Bulletin Number - BP2A - 01

Project	Steamboat I	Base Village Re	devel	opment		Date 05/26	/2021	
Project Location	Steamboat,	Colorado				Architect's Pro	ject Number 03.7	835.000
Owner/Client	Alterra Mour	ntain Company	/ Eas	t West Partners	S	File 6BL T	his is page 1 of	
То	Saunders Co	onstruction Inc.				Attention B	ryan Sculthorpe	
Address	86 Invernes	s Place North						
City	Englewood					State CO	Zip 80112 Code	
Delivered via:	П	Messenger	П	Hand carried	П	Facsimile		
Denvered via:		Express		Pick-up		E-mail Address		
		Mail		UPS		Website Address	BIM360	
This Bulletin Convey	s to Contractor (Check one of the fo	ollowing	g five choices.):				
Architect's Author		or Changes to the Work as des	cribed	below.				
		mental Instruction				, ,	ntal Instructions form	•)
Architect's Confir This confirms Archi Note: The above the is/are issued in acco	tect's verbal instr ree choices are ea	ructions to (individu ach subject to the fo	al's nar ollowing	me) on (date g terms: The change	e), a: e(s), clarific	s described below. ation(s) and/or confir	mation(s) described b	RCRBI

General: This bulletin addresses clarifications to Gold Walk's door schedules, door hardware, and room numbering for pe

Scale
NOT TO SCALE

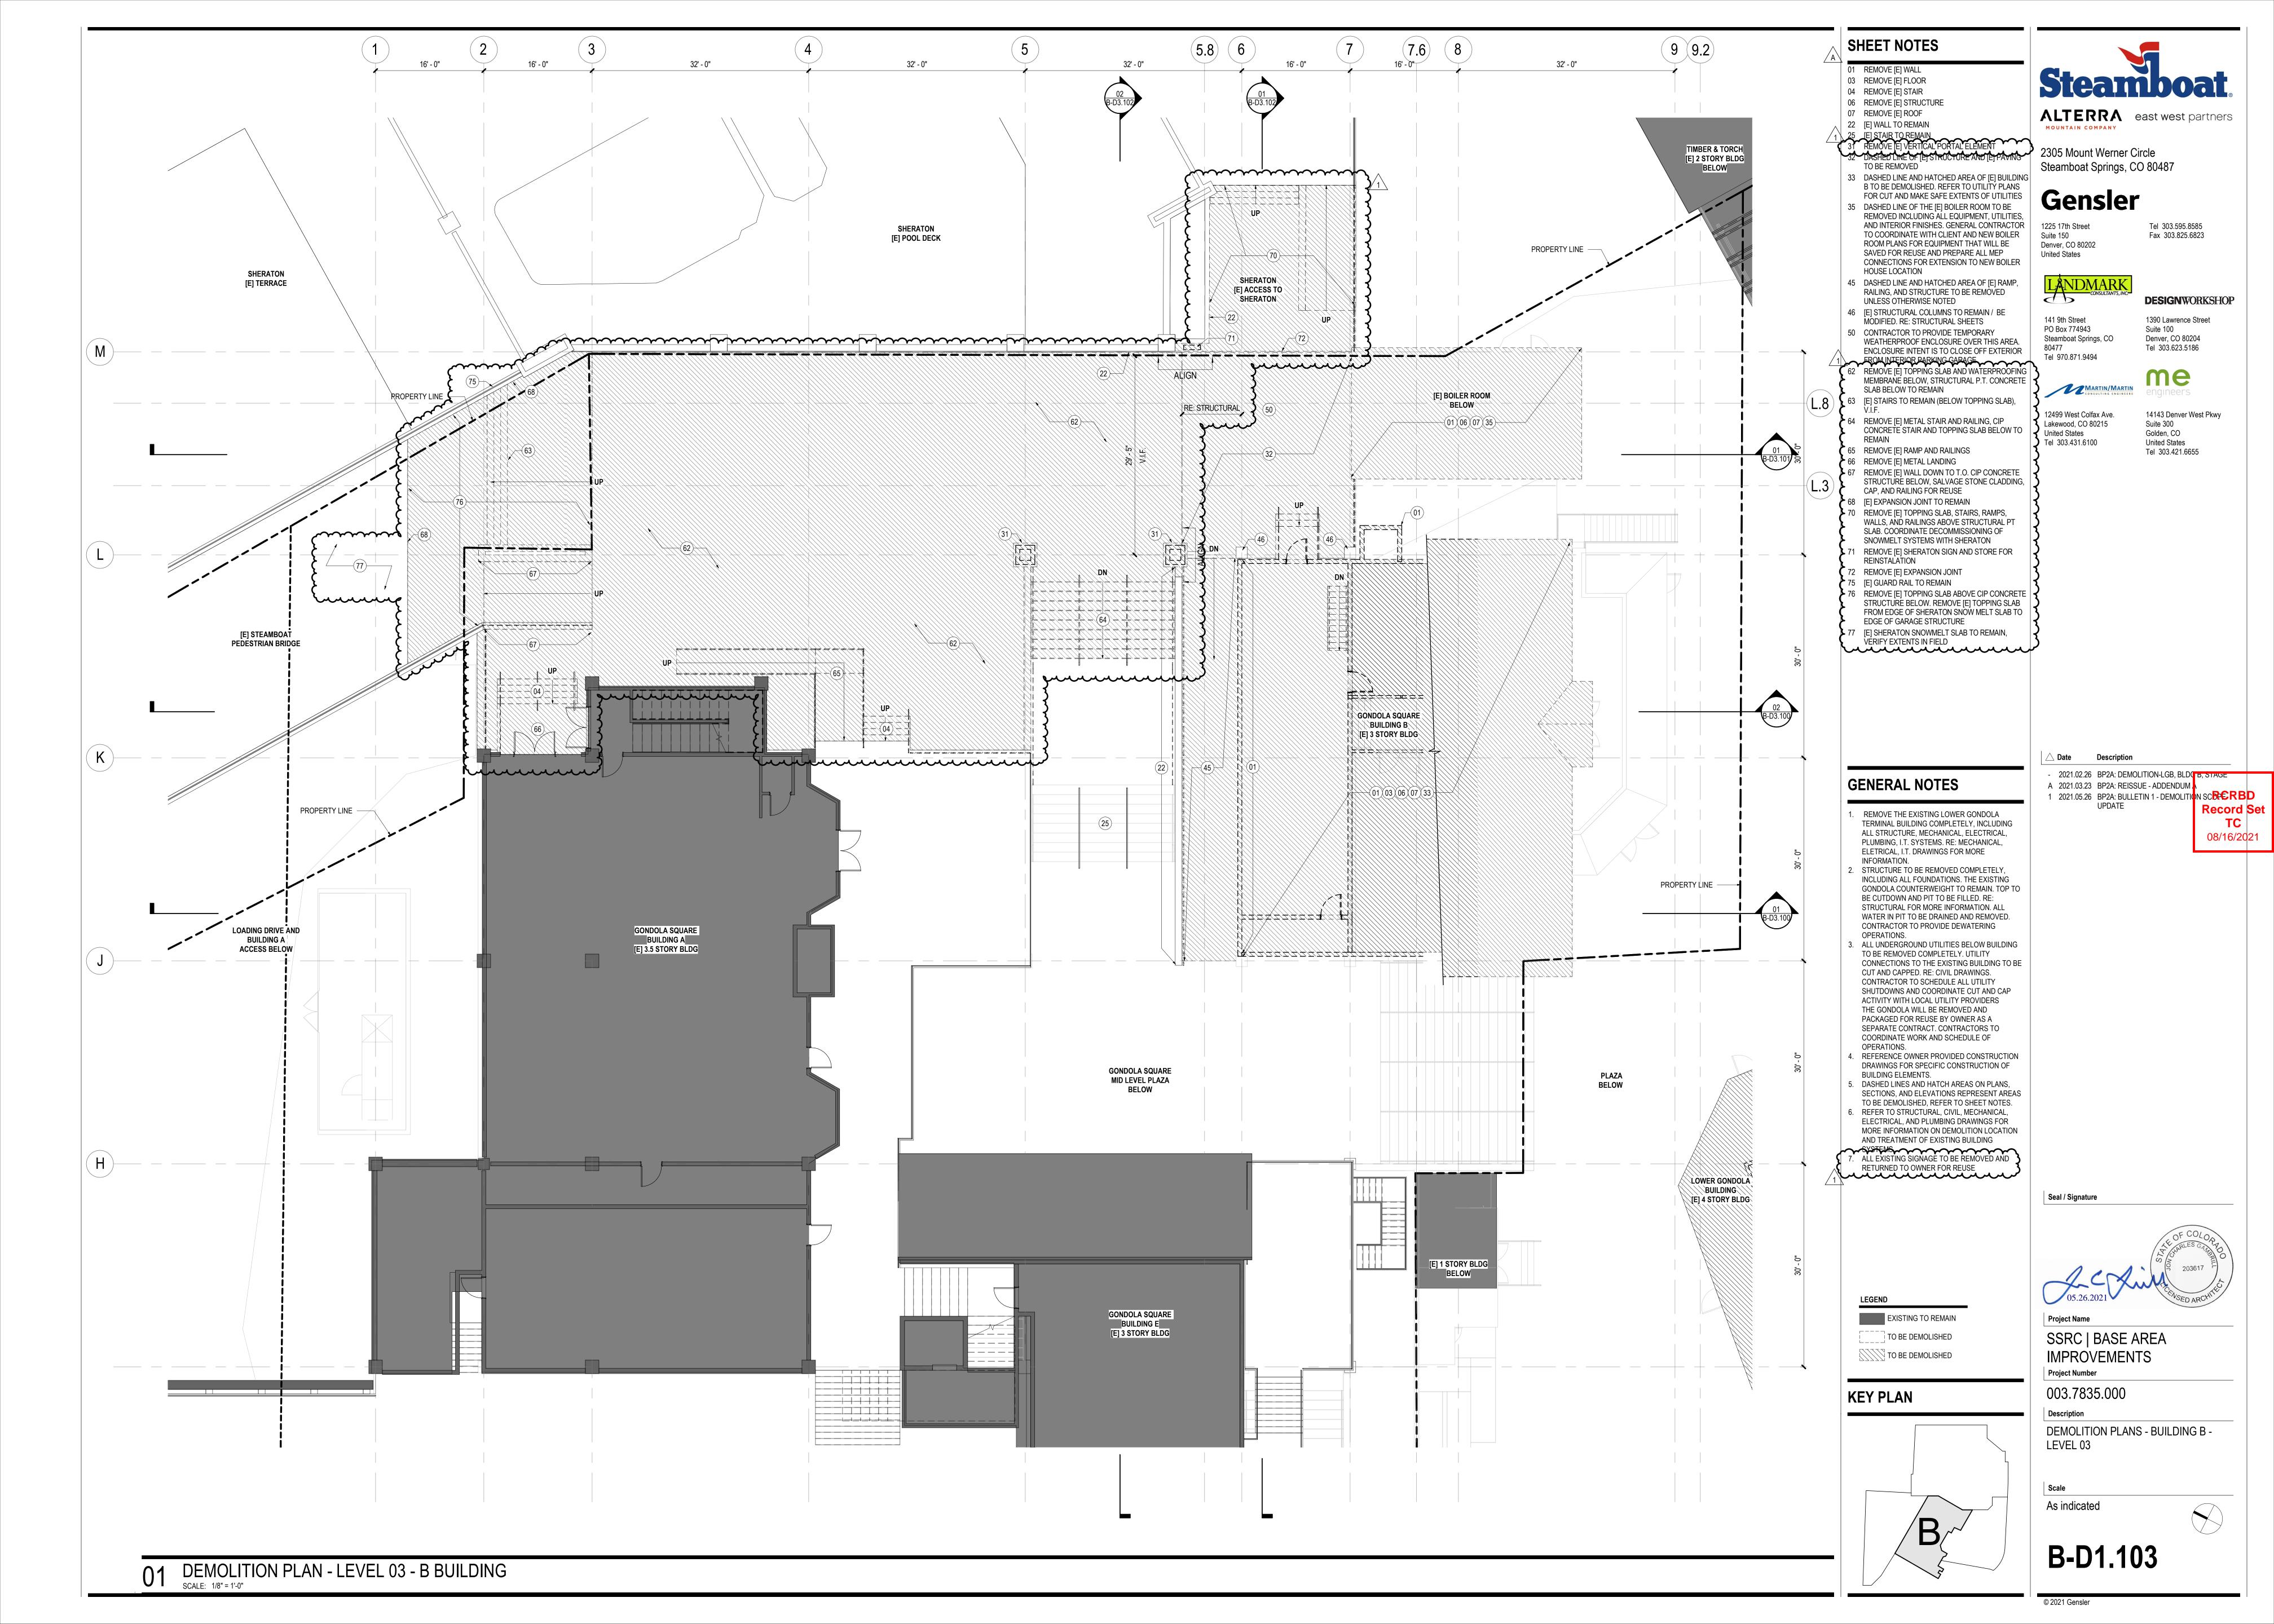
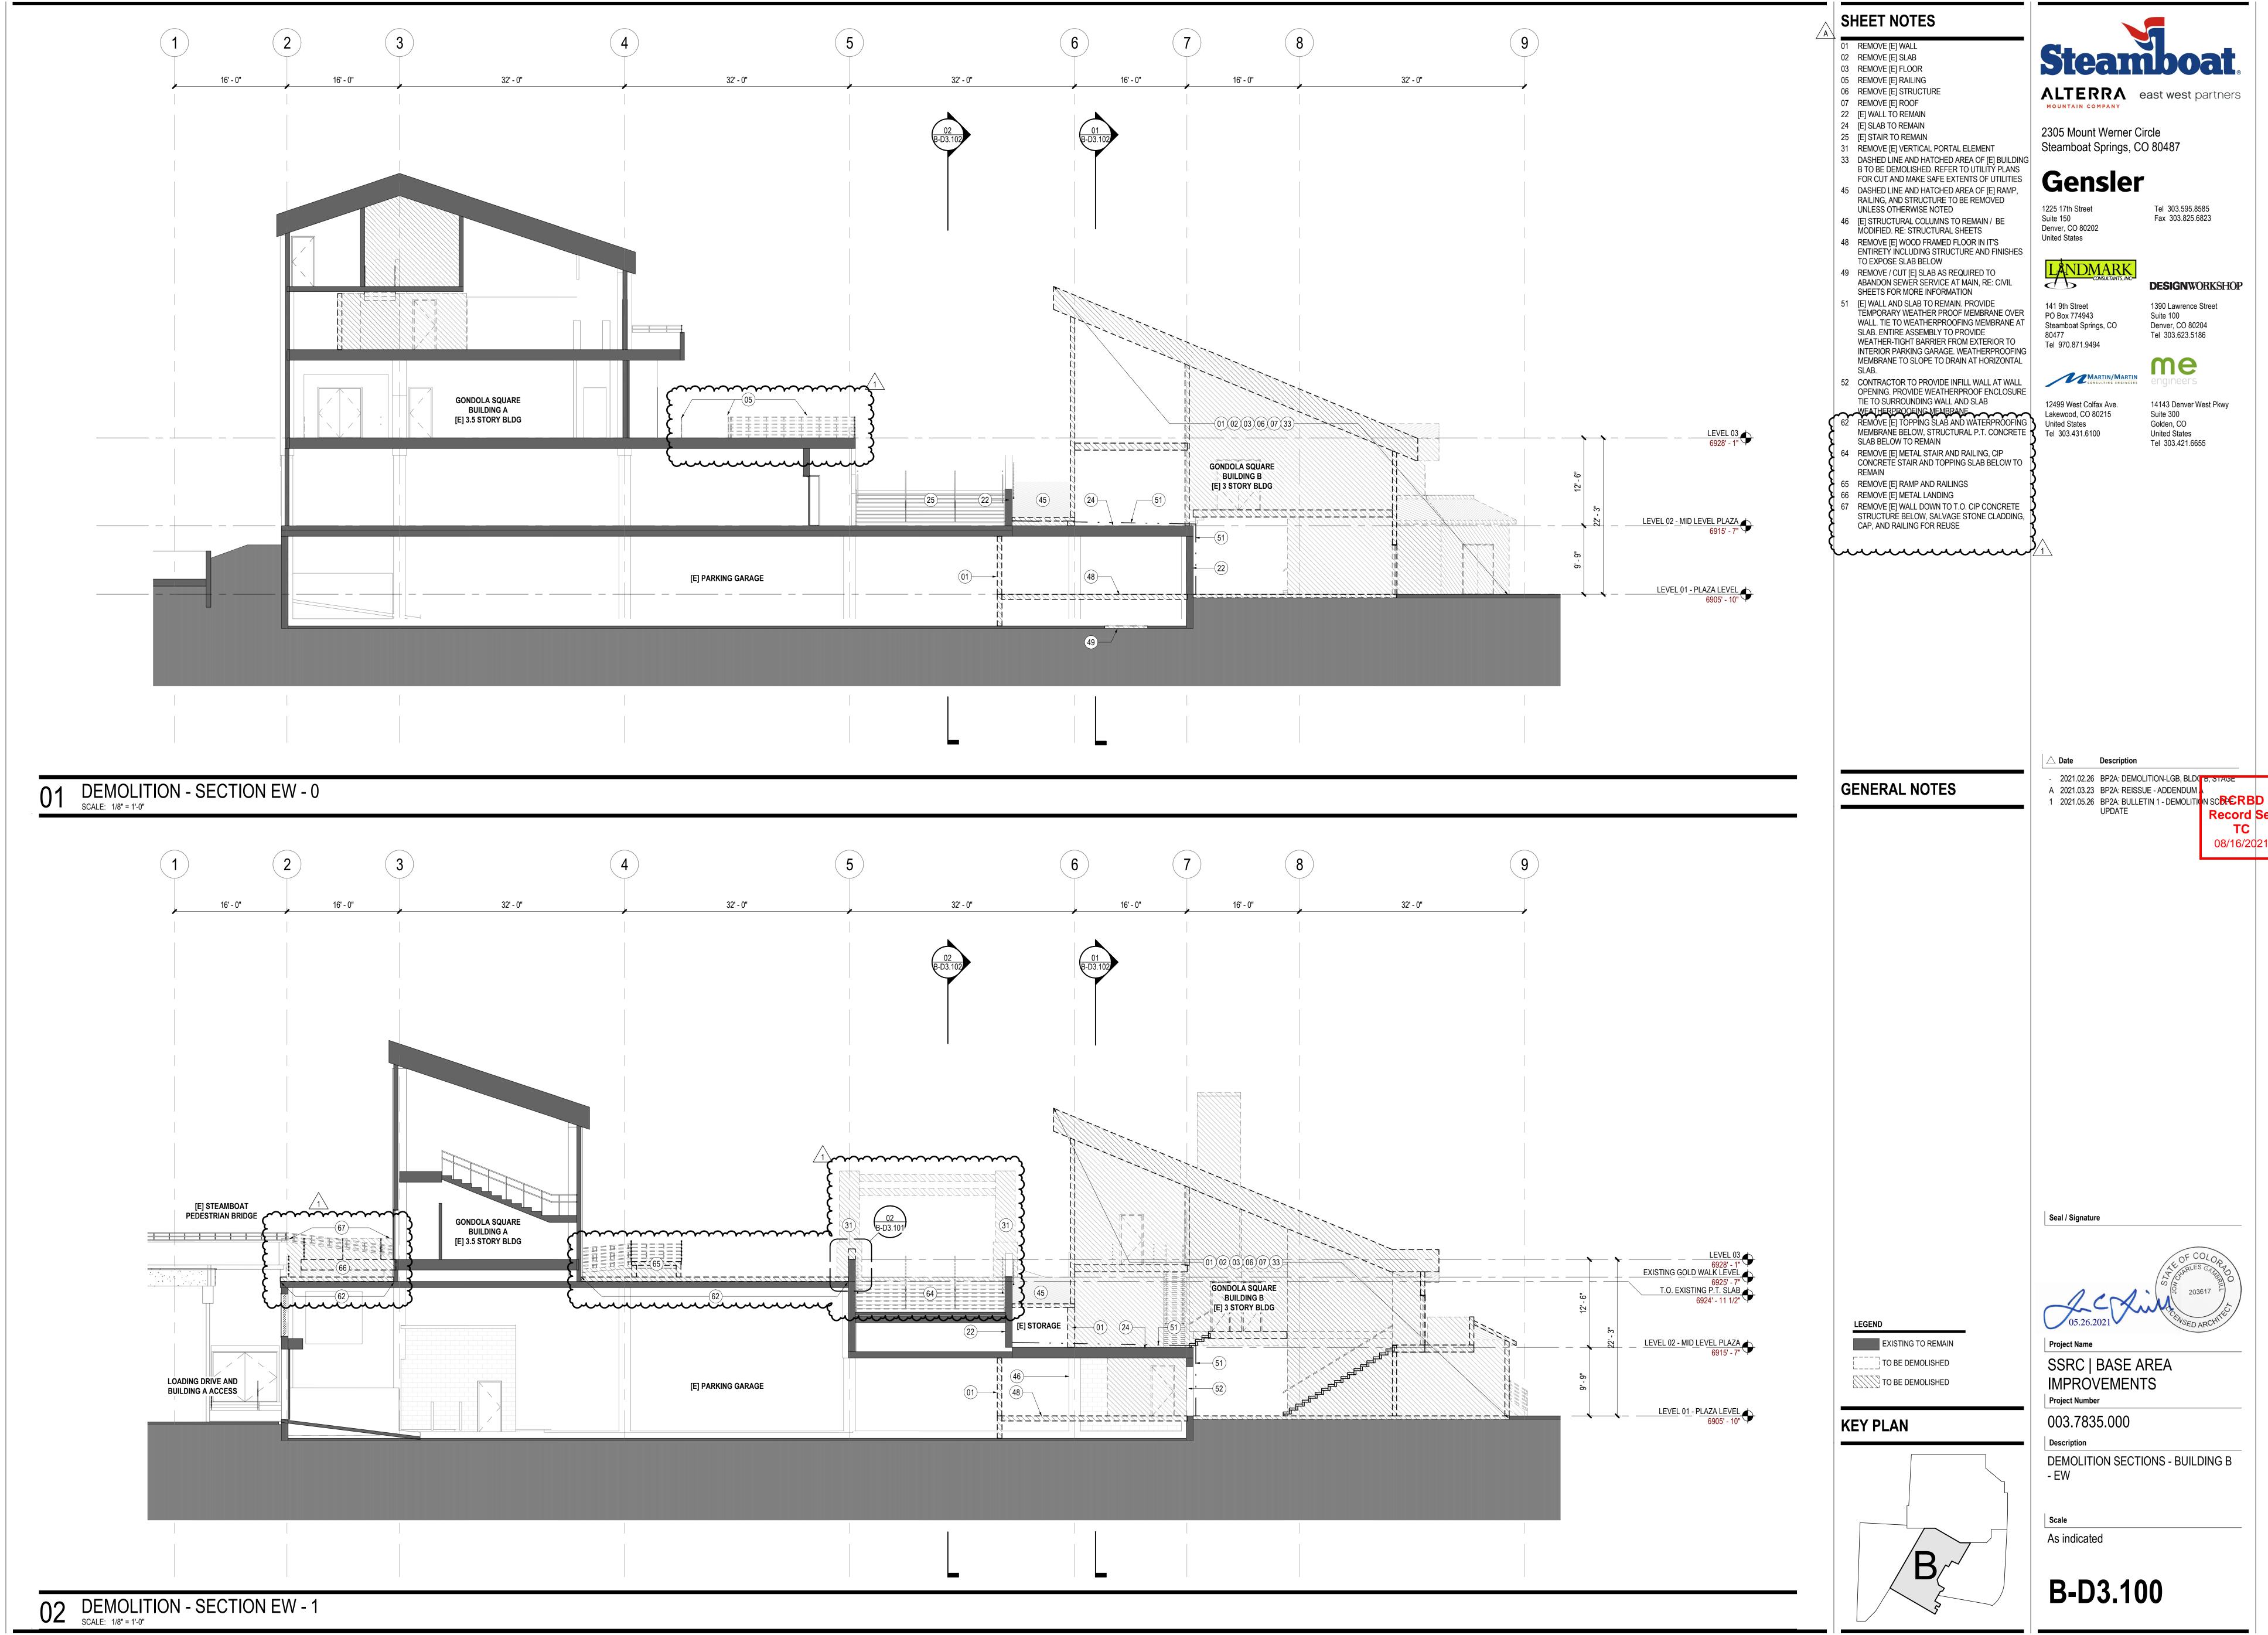
- c. Added Demolition Detail 03, 04 and 05
 - d. Sheet notes Added note #58 and 69
- 5. A-D4.100 DEMOLTION AXONOMETRIC LOWER GONDOLA BUILDING & STAGE
 - a. Axon NW Revised indicated scope

- b. Axon SW Revised indicated scope
- 6. B-D1.101 DEMOLITION PLANS BUILDING B LEVEL 01
 - a. 01 DEMOLITION PLAN LEVEL 01 B BUILDING Portion of garage wall shown as removed
